Architectural Design Review Board

May 5, 2020 @ 4:00 P.M. Council Chambers First Floor, 345 High Street Hamilton, Ohio 45011

| To: From: Subject: | Architectural Design Review Board Daniel Tidyman– ADRB Secretary AGENDA ITEM # 1 622 Dayton Street – Fencing | | | |

The Applicant, Shi O'Neill, has submitted a Certificate of Appropriateness Application for the property of 622 Dayton Street. The proposal involves fencing.

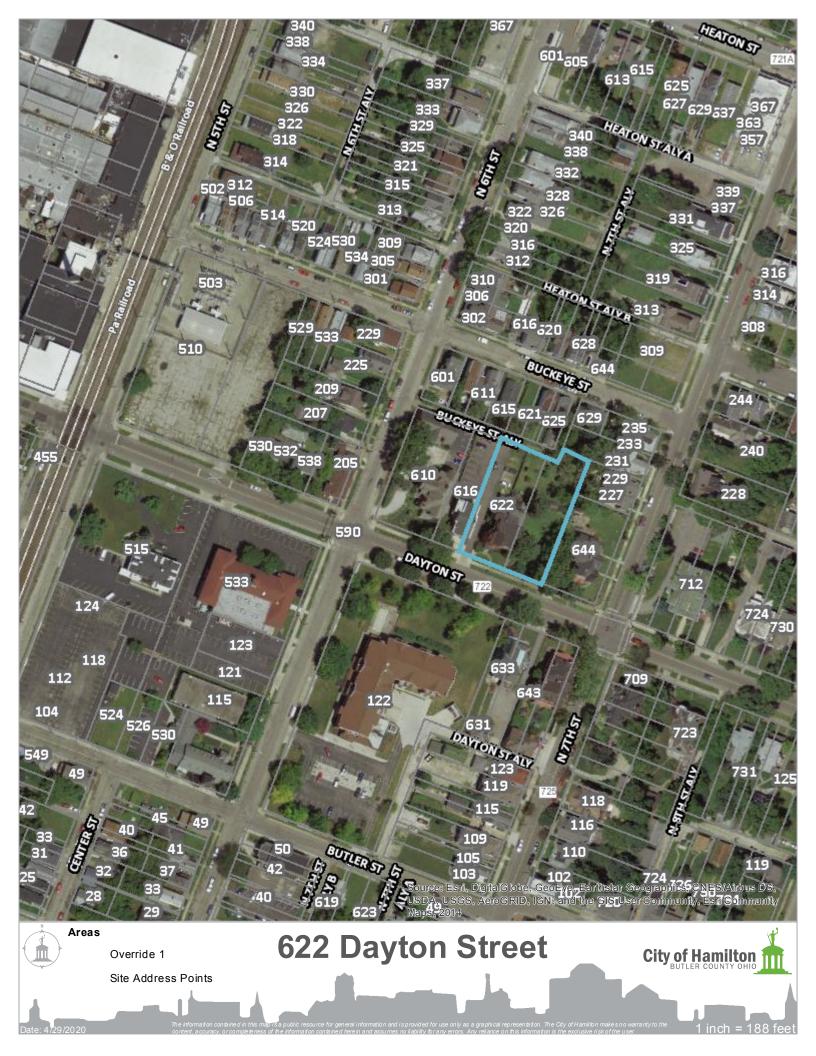
- Fencing:
 - Existing:
 - Front yard: Ornamental fence
 - East Side Yard: Picket fence, galvanized fence posts for chain link fence.
 - Proposed:
 - Removing existing picket fence
 - Install chain link fence
 - Run from behind large tree on property to rear of property
 - Screened by trash and recycling bins from neighboring property (644 Dayton)
 - Partially screened from existing ornamental fence in front of property
 - Planting climbing vines (honeysuckle and clematis)
 - Can install sand cherry bushes along the fence line for additional screening.

This application broaches the topic of fencing in the ADRB Policies and Guidelines. They board may approve chain-link fences if they follow one of multiple constraints. The constraint that aligns the most with the proposal includes using chain-link fencing with the same color and height of another appropriate type of fencing that is prominent on the property. This includes using the black chain link fence to continue from the existing ornamental fencing located in the front yard of the property. Additionally, the chain link fence can be screened with shrubbery.

The ADRB cab approve, modify, or deny the COA request for fencing. Should the ADRB decide to approve the COA request, the Planning Department recommends the following motion:

To approve the COA request for fencing given the following finding:

1. That COA request is compliant with Section 1126.50 of the Hamilton Zoning Ordinance.
